DOCUMENT 00 90 00
ADDENDUM

ADDENDUM NO. [2] **Date: May 9, 2019**

RE: **HOUSING AUTHORITY OF LA CROSSE**
2018-19 CAPITAL IMPROVEMENT PROJECTS
1307 BADGER STREET
LA CROSSE, WI 54601
HSR PROJECT NO. 18065

A360

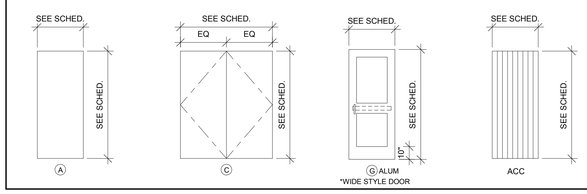
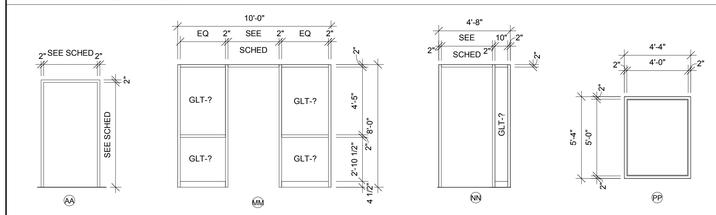
3. Sheet A360 DOOR SCHEDULE – STOFFEL COURT 30 x 42 attached hereto
    a. Revisions clouded on Drawing.
    b. To clarify Remark 6: To include doors for 4th and 5th floor, Doors 301A thru 318 are duplicated as 401A thru 418 and 501A thru 518. These numbers have been added to the attached door schedule.
    c. Accordion door widths changed from 5'-8" to 5'-0".
